## Arklow Flood Relief Scheme

Response to Submissions relating to  
Planning & Environmental Matters  
(ABP ref 301368-21 & 310377-21)

D5246

Issue | 12 January 2022

Date: 12.03.18	Scale: 1/500	Drawn: NM	Chk: SH	App: KT
Project No: PH00886/01	Drw. No: 1041			Rev: P8

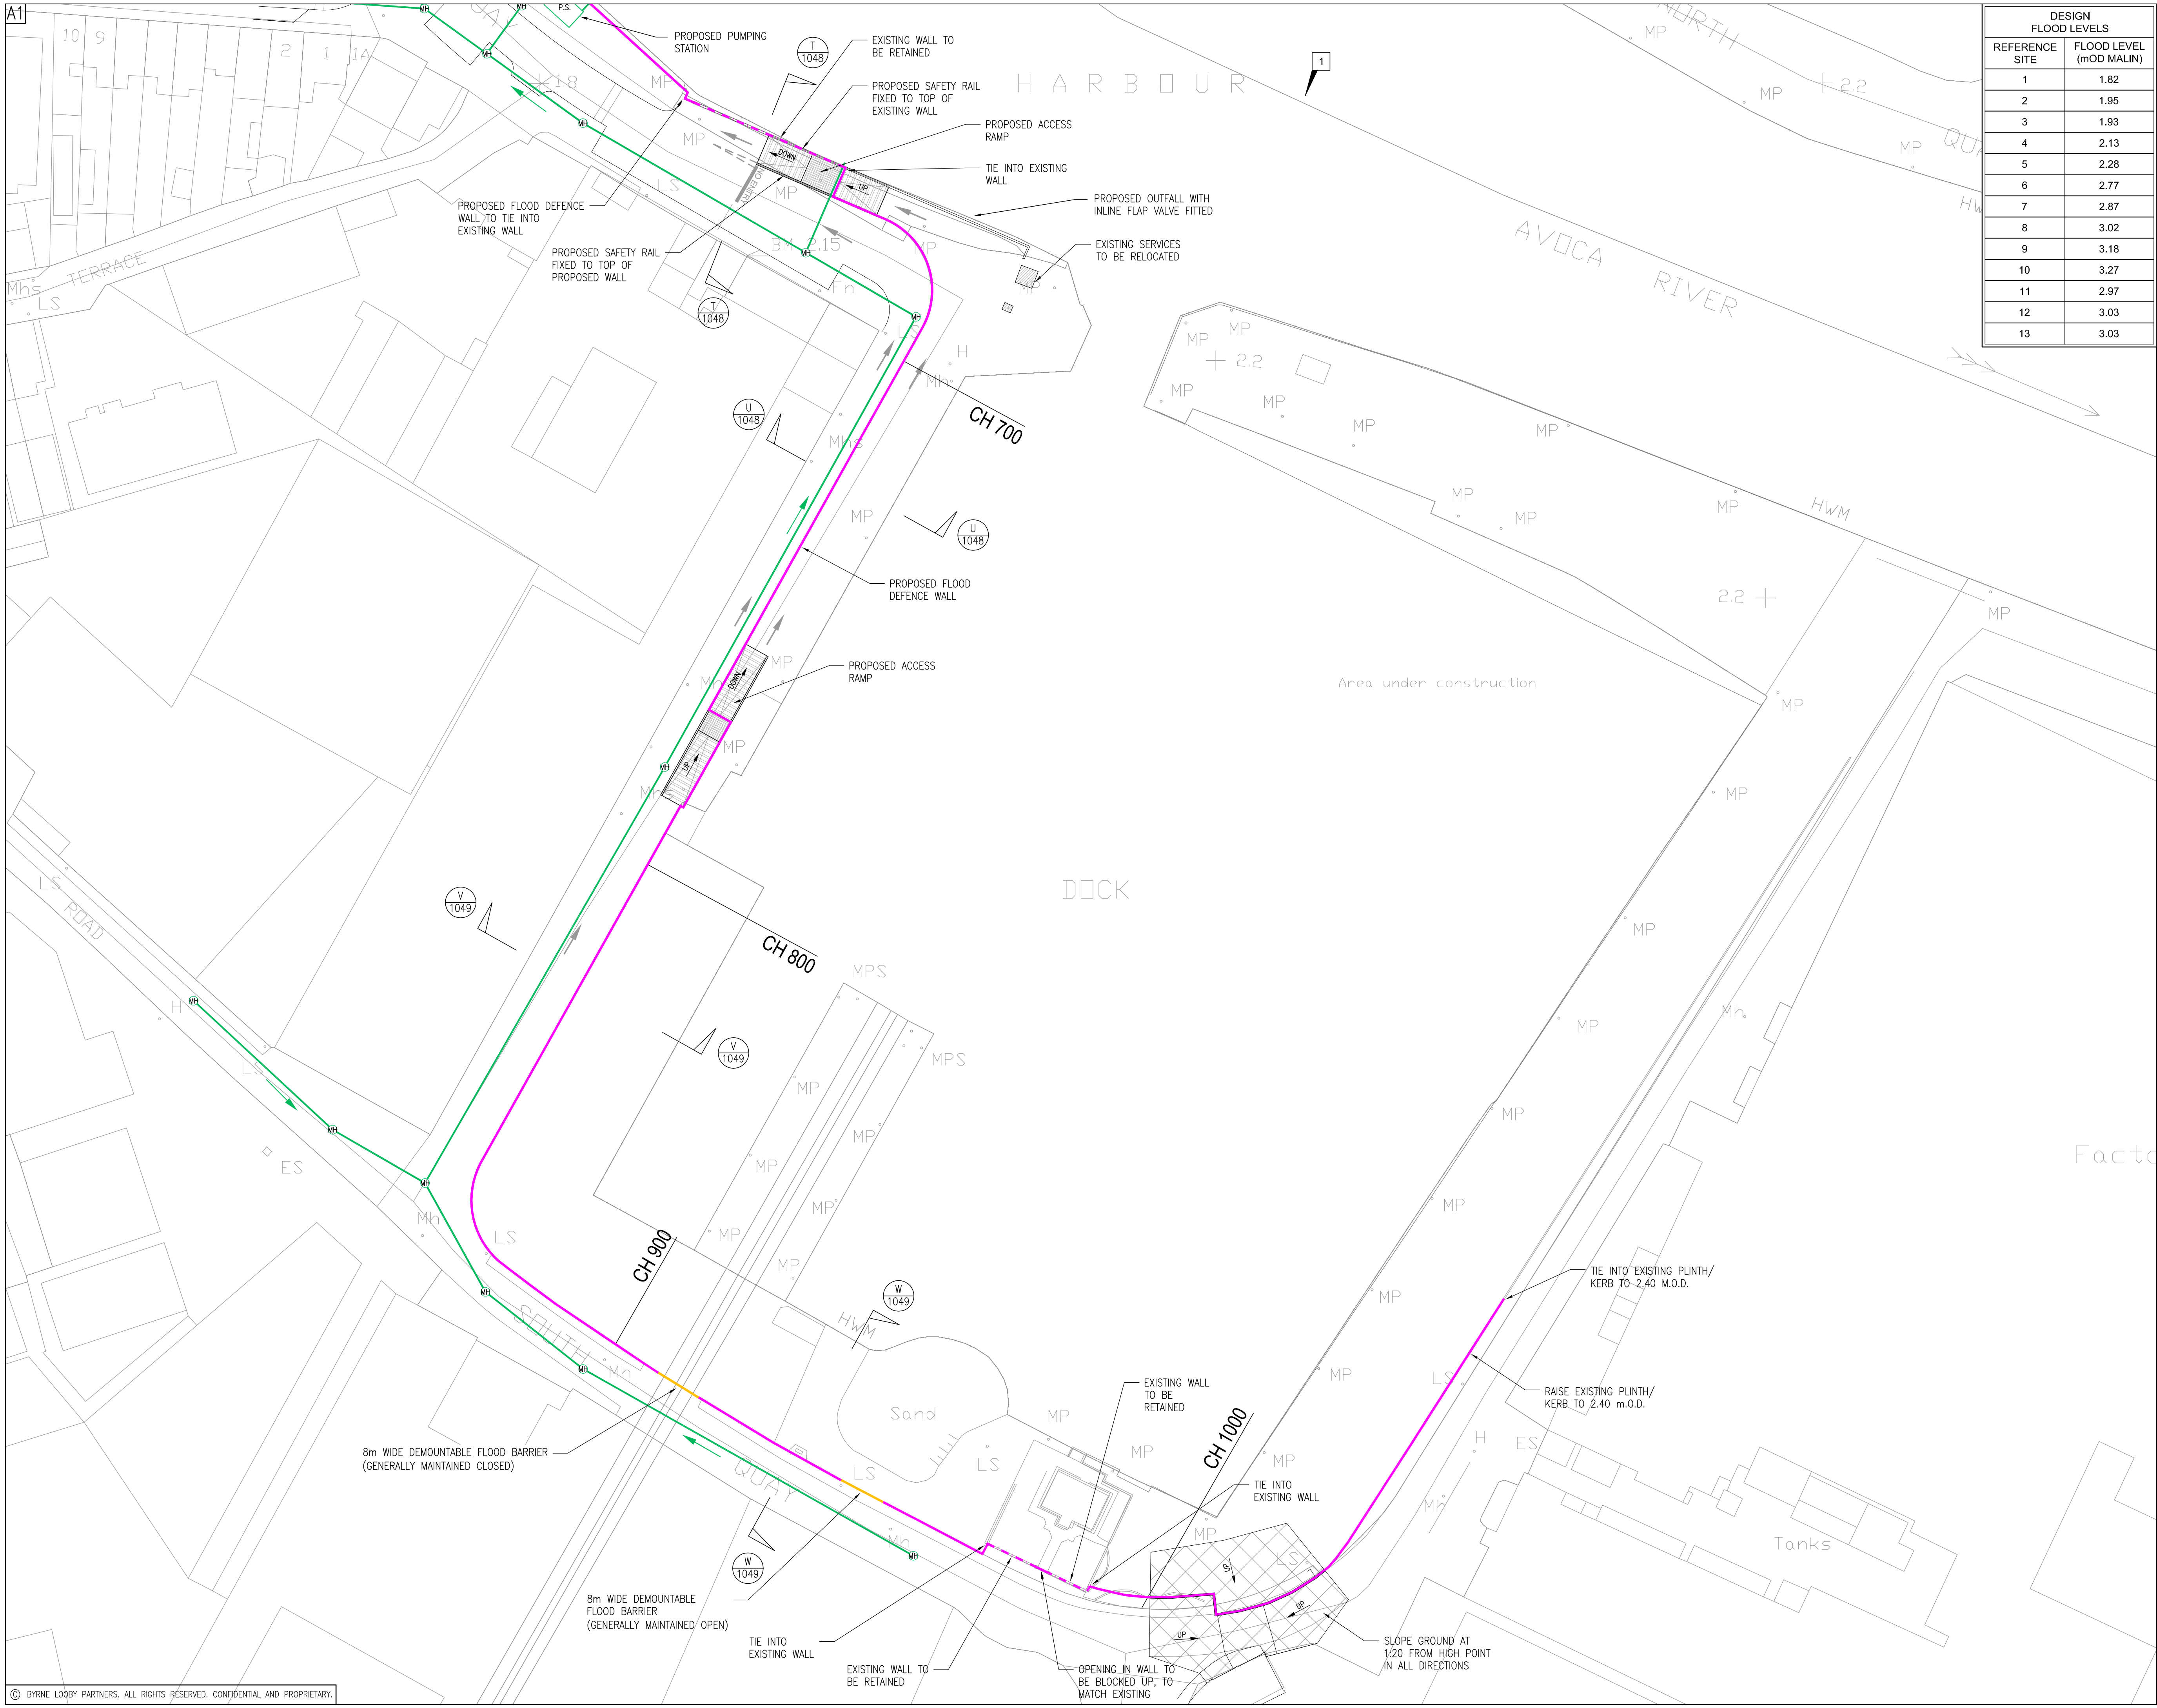
In response to the submissions/objections received by ABP, it is now proposed to include an additional 30.0m of glazing at the following locations listed below. Drawing Nos 1036-1042 and 1046 of Appendix 4.1 (*Scheme Drawings*) and Drawing Nos 301-302 of Appendix 4.2 (*Landscape Design and Public Realm Drawings*) of the EIAR have been revised to reflect these changes and are included in **Appendix A** of this report.

- Addition of two 6.0m long glass panels just downstream of Arklow Bridge on South Quay at approximately Ch 020 (12.0m total), as shown on revised Scheme Drawing No 1040 and revised Landscape Design and Public Realm Drawing No 301 in **Appendix A** of this report. This will open up views of the bridge downstream.
- Addition of three 6.0m long glass panels along South Quay at approximately Chainage 370 (18.0m total), as shown on revised Scheme Drawing No 1041 and revised Landscape Design and Public Realm Drawing No 302 in **Appendix A** of this report.
